SECTION III

Retype of the Proposed Change

Determination of Significant Hazards for Proposed Change

FIGURE 2.1-1

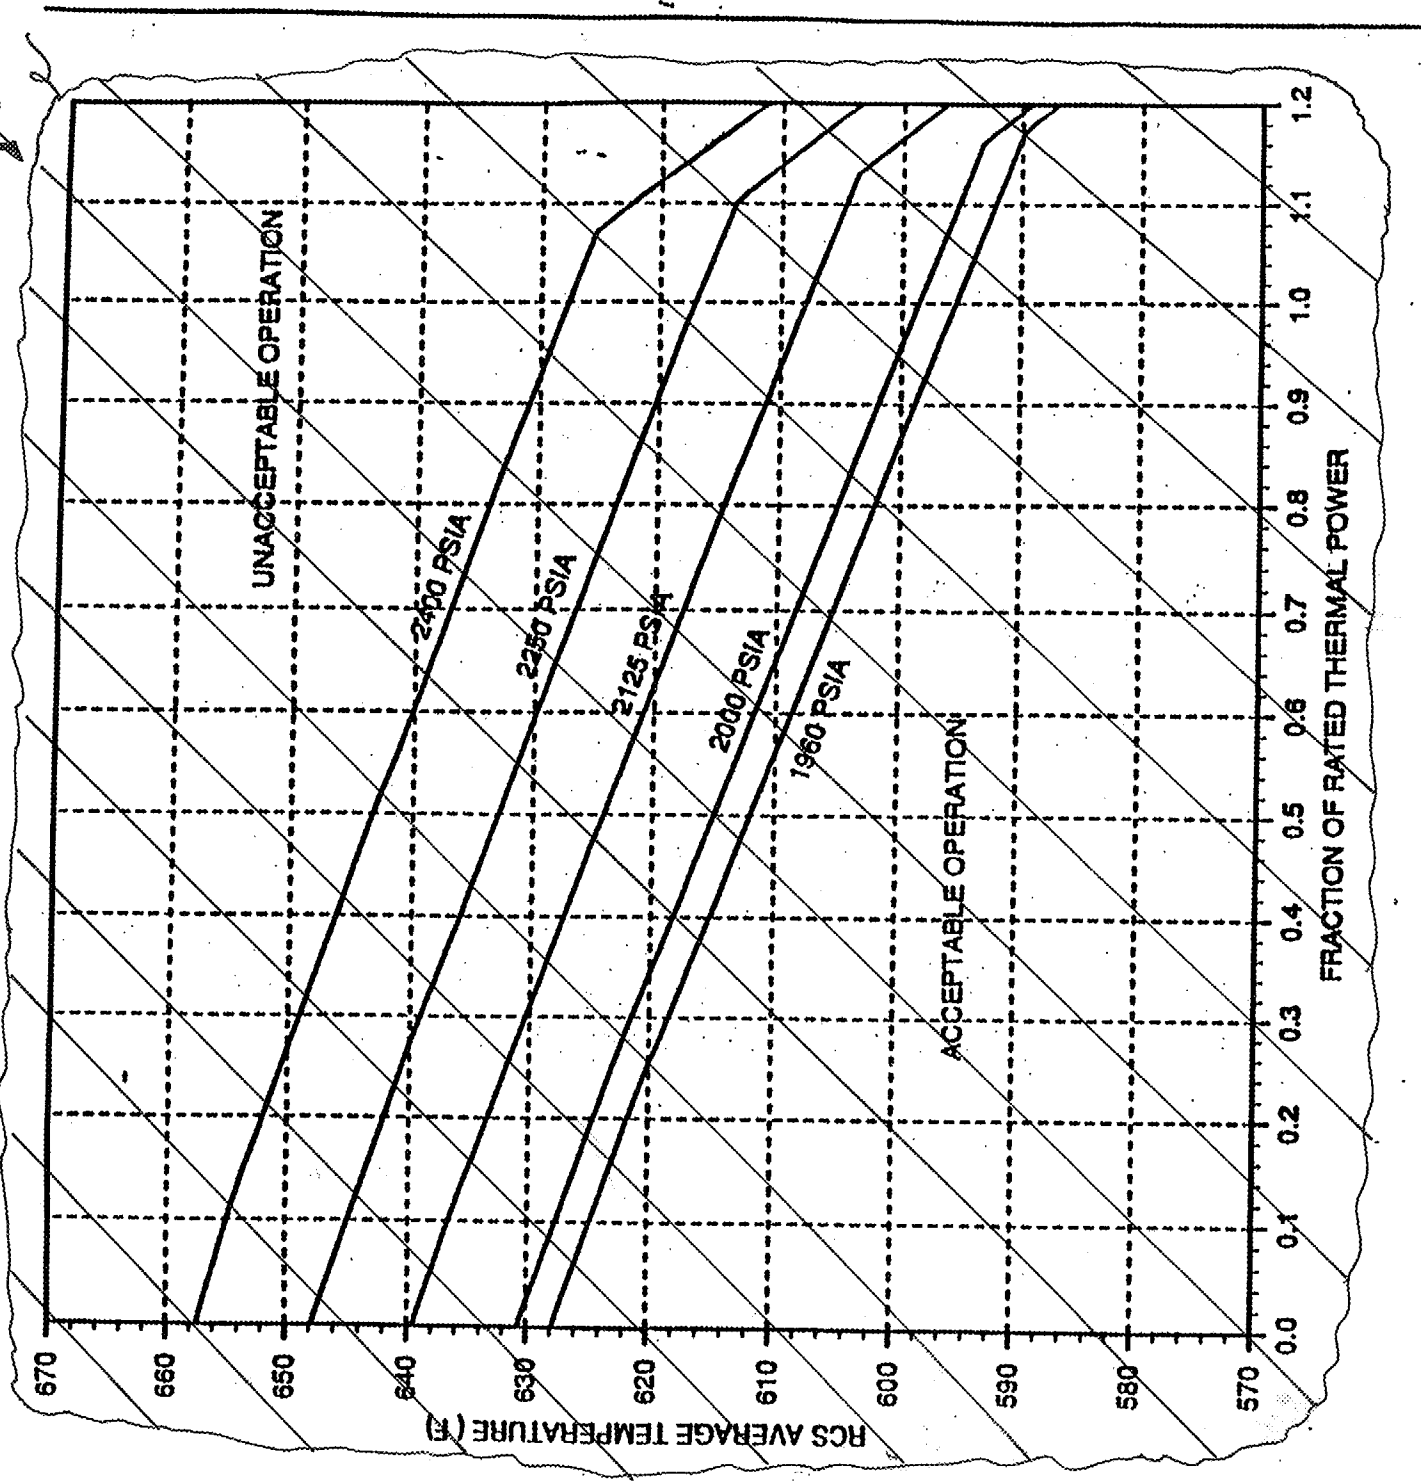
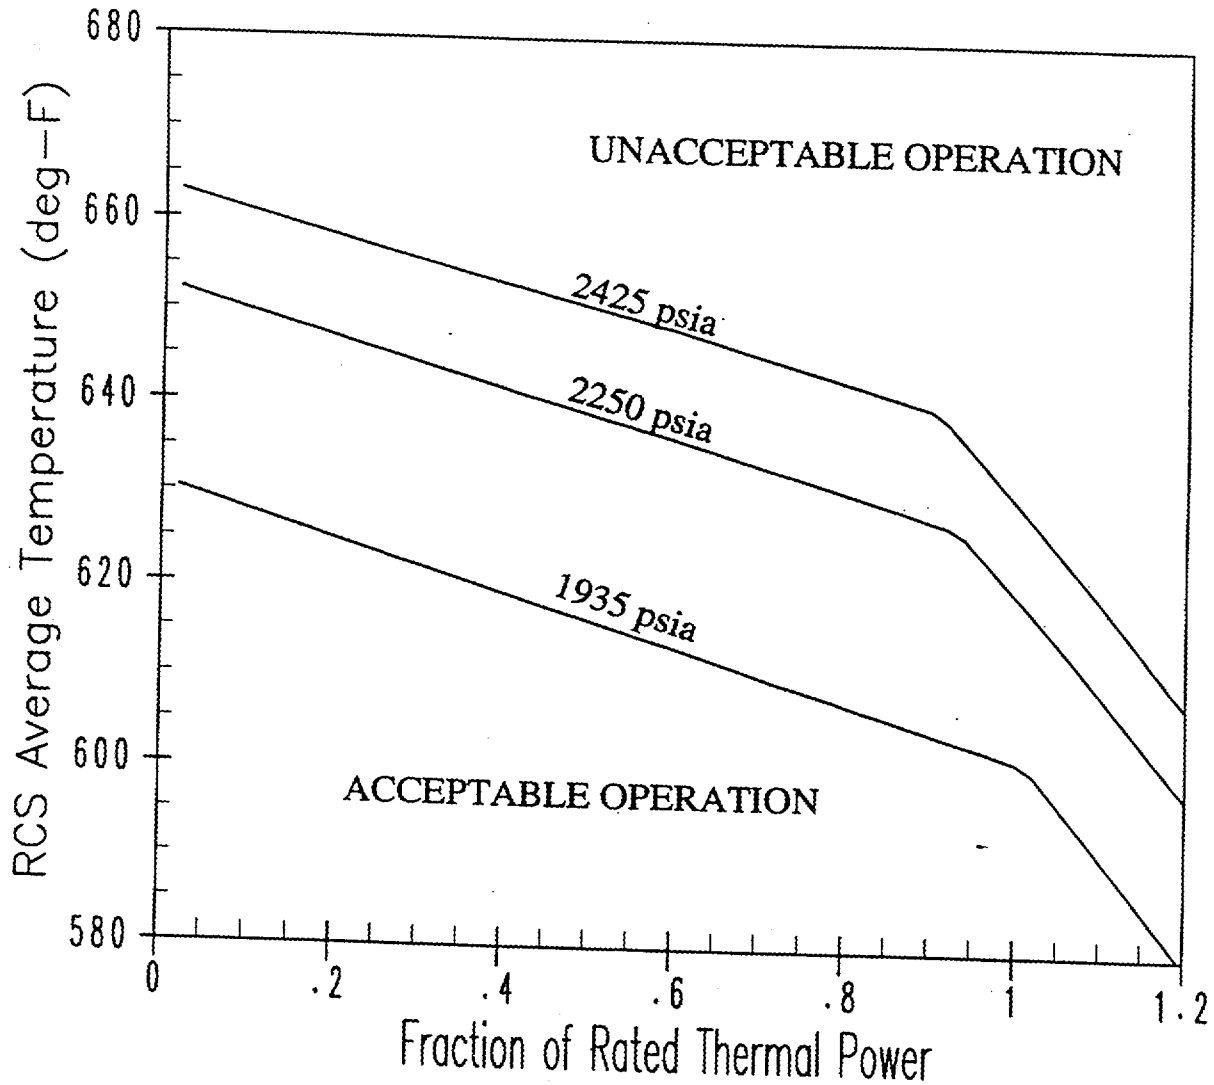
REPLACE WITH ATTACHED NEW FIGURE 2.1-1

INSERT
①

NEW FIGURE 2.1-1

Figure 2.1-1

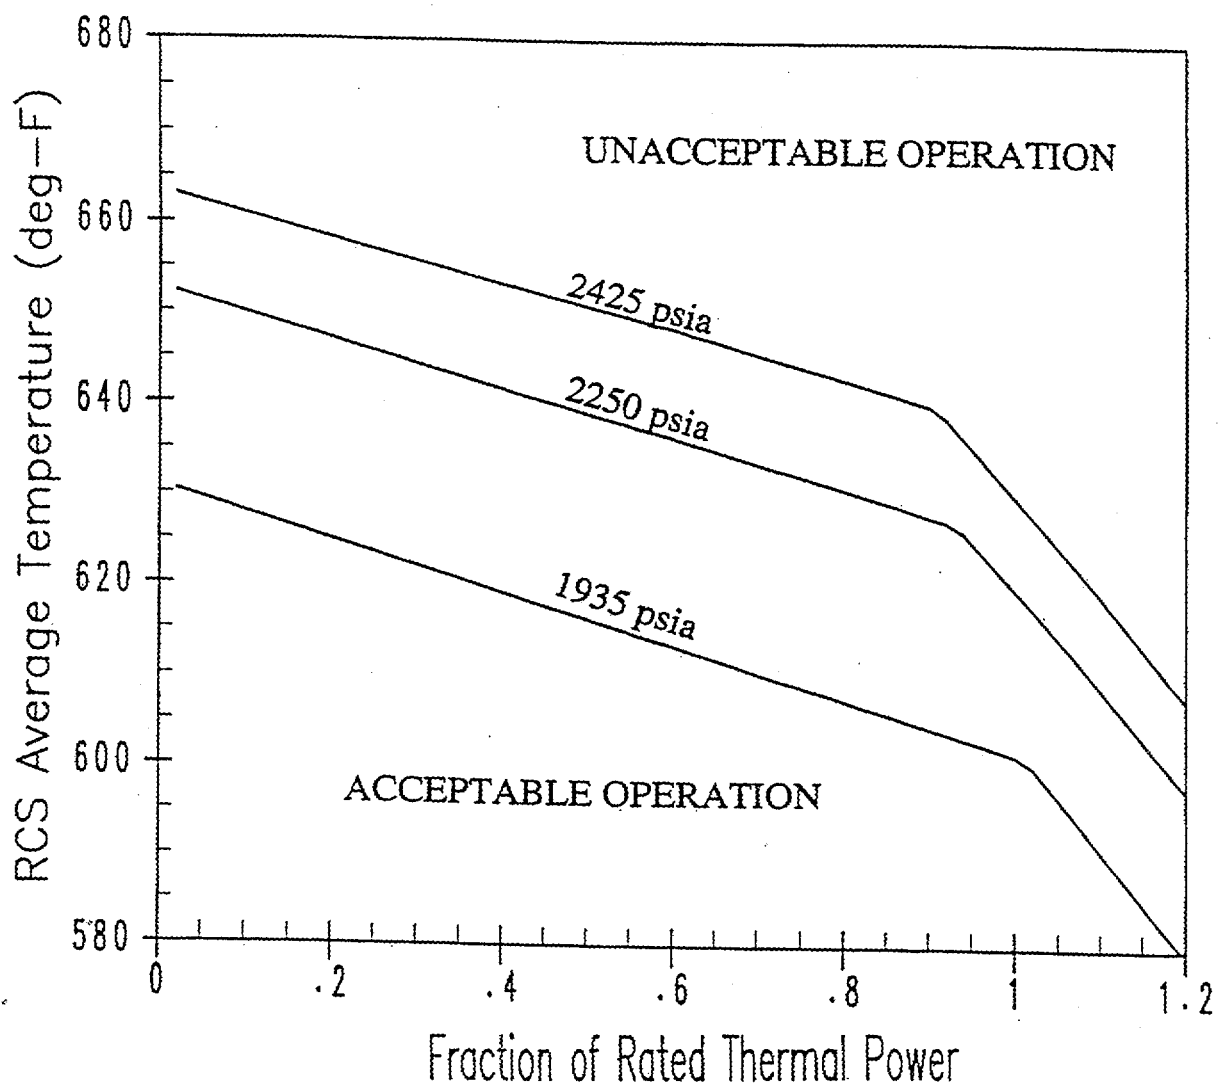
The curves of Figure 2.1-1 show the loci of points of THERMAL POWER, Reactor Coolant System pressure, and average temperature for which the minimum DNBR is no less than the safety analysis DNBR limit value, or the average enthalpy at the vessel exit is equal to the enthalpy of saturated liquid.

This expression conservatively bounds the cycle specific limits on $F_{\Delta H}^N$ specified in Technical Specification 3/4.2.3 and the COLR. The Safety Limits in Figure 2.1-1 are also based on a reference cosine axial power shape with a peak of 1.55.
